## **SERVICE BULLETIN**

### **SERVICE BULLETIN INDEX**

FIGURE 1  
COMPRESSOR OUTLET DUCT COUPLING INSTALLATION

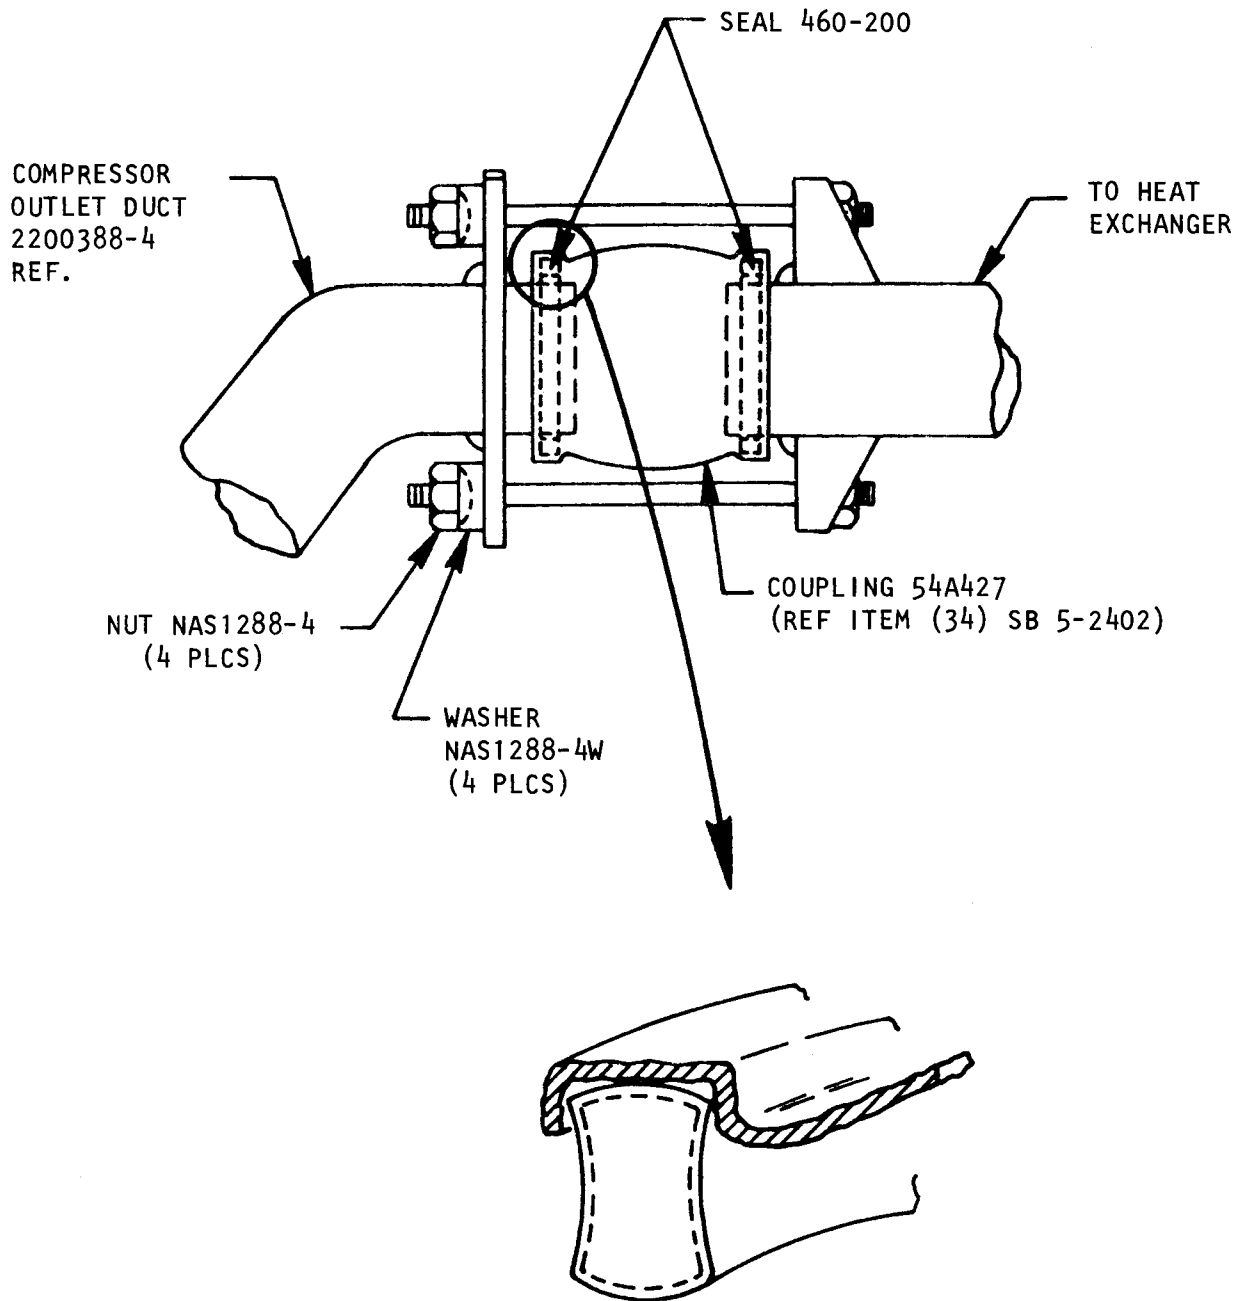
\*\*See Figure 1 for seal installation.

Aircraft Refrigeration Unit  
Part No. 2200165-2 and 2200165-3  
Figure 1

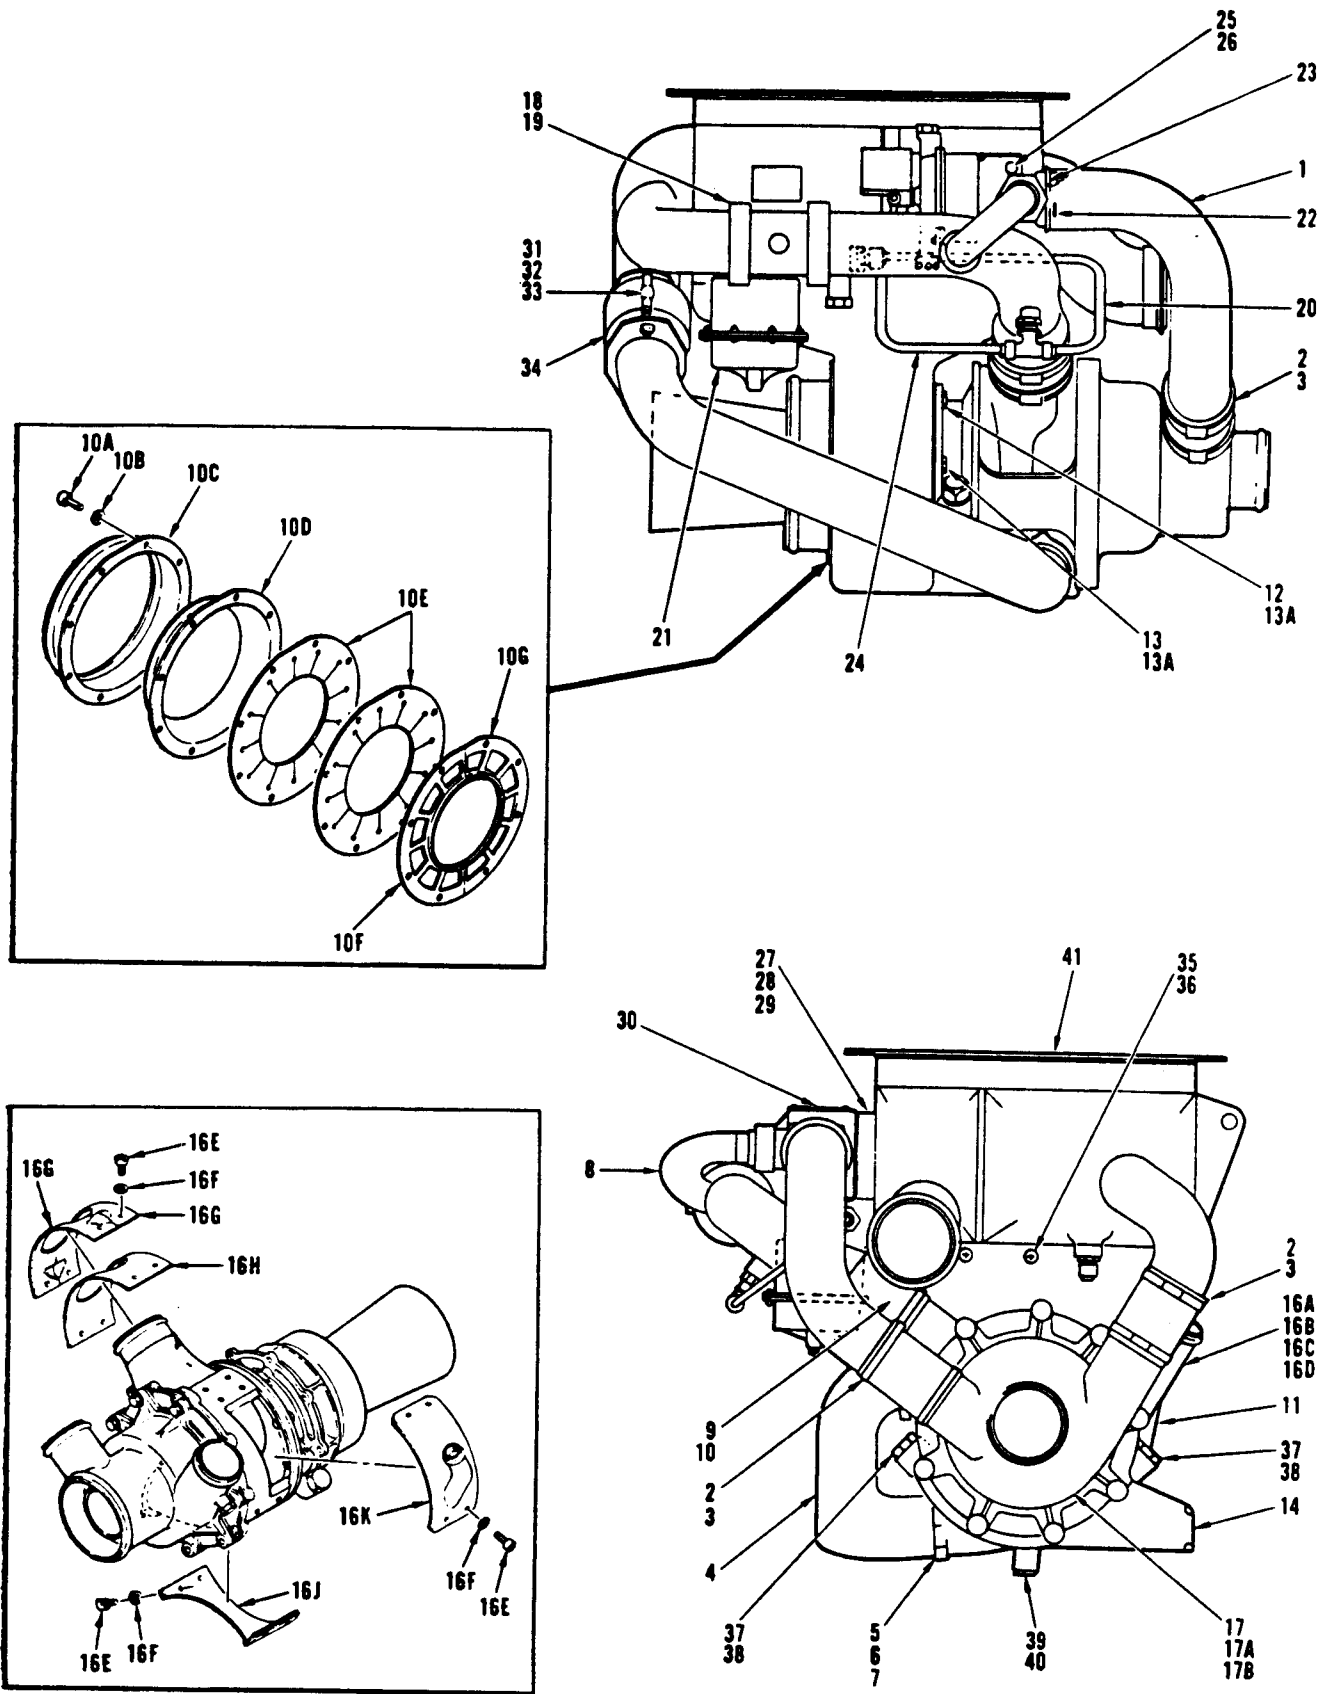
- (1) Remove 2200392-1 Regulating Valve Supply Pressure Tube Assembly (20, figure 1).
- (2) Remove 2200388-1 Compressor Outlet Duct Assembly (4) by removing three screws (5), nine washers (6), one packing (7), four nuts (31), four washers (32), two studs (33), and coupling (34) as shown in figure 1. Retain attaching hardware.

- (4) Remove 898730-1 Fluid Pressure Regulating Valve (21, figure 1) by removing two clamps (18) and two packings (19) as shown in figure 1. Retain attaching hardware

- (3) Install new 2200388-4 Compressor Outlet Duct Assembly (4A, figure 2) and secure with three screws (5), nine washers (6), one packing (7), four nuts (31), four washers (32), two studs (33), and coupling (34) as shown in figure 2.

- (5) Install new 898730-3 Fluid Pressure Regulating Valve as shown in (21A, figure 2) and secure with two packings (19) and two clamps (18) as shown in figure 2.

- (6) Remove one each bolt (12, 13) from positions shown in figure 2, Section A-A. Install new 2202815 Regulating Valve Mounting Bracket (18A), using washers (13A) and bolts (12, 13) as shown.

- (7) Install new 3214102-8 Air Supply Regulating Valve (18B) to 2202815-1 Regulating Valve Mounting Bracket (18A) using four new AN960PD10L Washer (18C), two new AN3C6A Bolts (180), and two new MS21042-3 Nuts (18E) as shown in figure 2.

- (8) Install new 129658-1 Pneumatic Thermostat (18F) and 2202718-1 Gasket (18G) to duct assembly (4A) using two new AN3C4A Bolts (18H), four new AN960PD10L Washers (18J), and two new MS21042-3 Nuts (18K) as shown in figure 2.

FIGURE 1

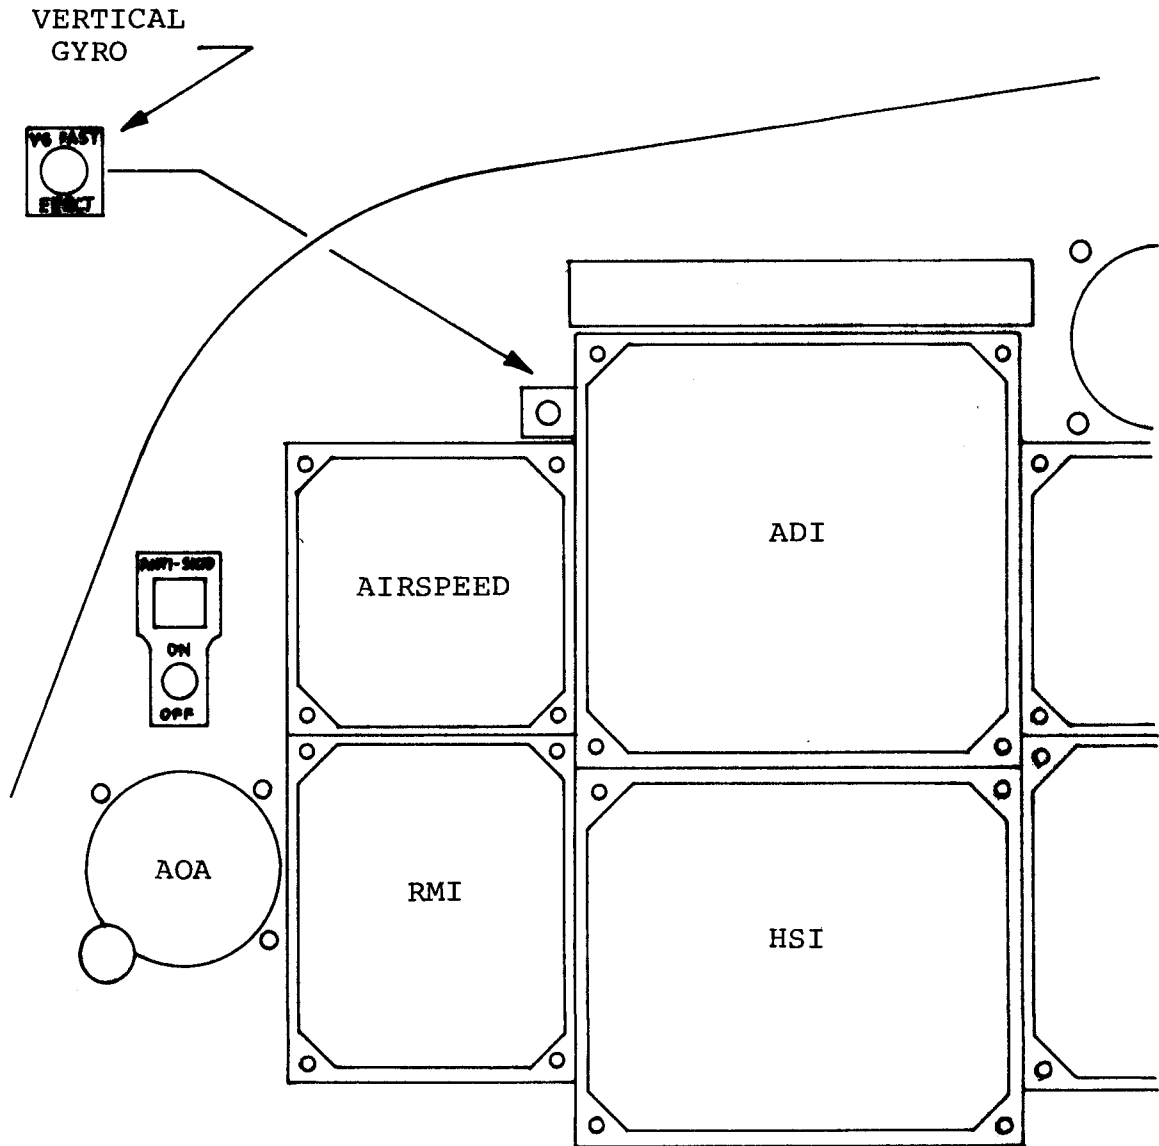
- (4) Locate vertical gyro fast erect switch on pilots instrument panel as shown in Figure 1, using standard shop practices. (Switch installation on copilot's panel is typical for aircraft with dual vertical gyro installations).

- (4) Locate vertical gyro fast erect switch on pilot's instrument panel as shown in Figure 1 or 2, using standard shop practices, (Switch installation on copilot's panel is typical for aircraft with dual vertical gyro installations).

FIGURE 1

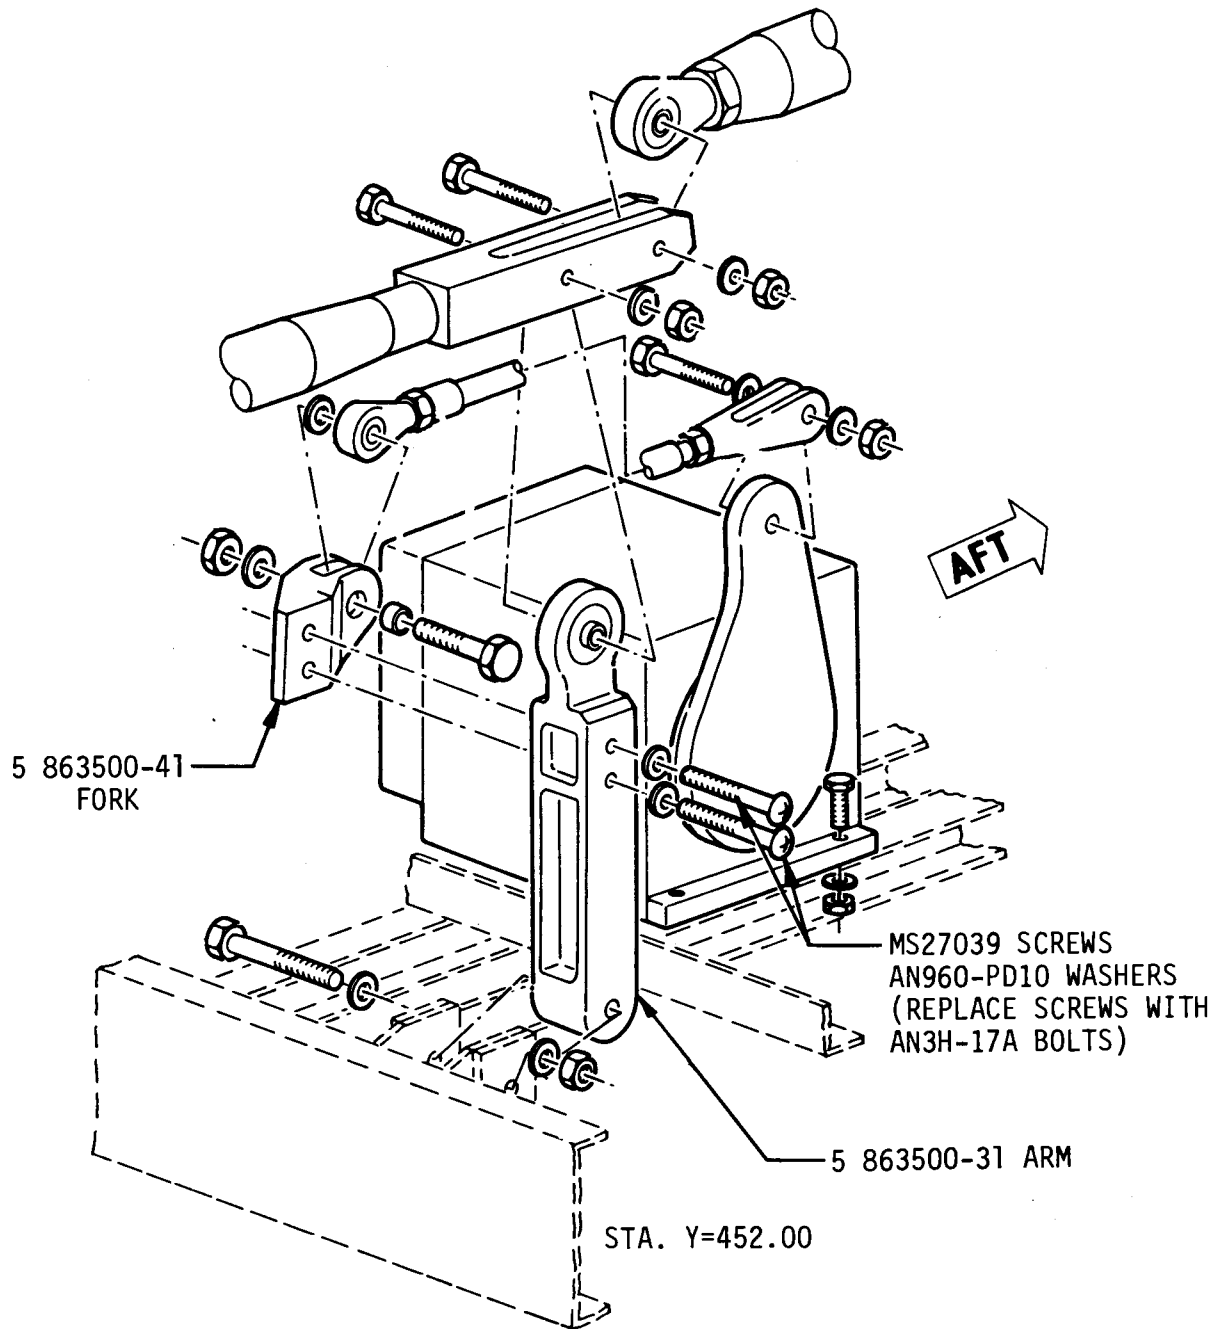
- A. Remove overhead access panels in aft baggage compartment as necessary to gain access to P/N 863500-31 arm and 863500-41 fork, ref. Fig. 1.
- B. Remove 2 each MS27039 screws and 2 each AN960-PD10 washers, discard screws and retain washers.
- C. Install 2 each AN3H-17A bolts with AN960-PD10 washers under heads. Torque to 20-25 inch-pounds and safety wire.
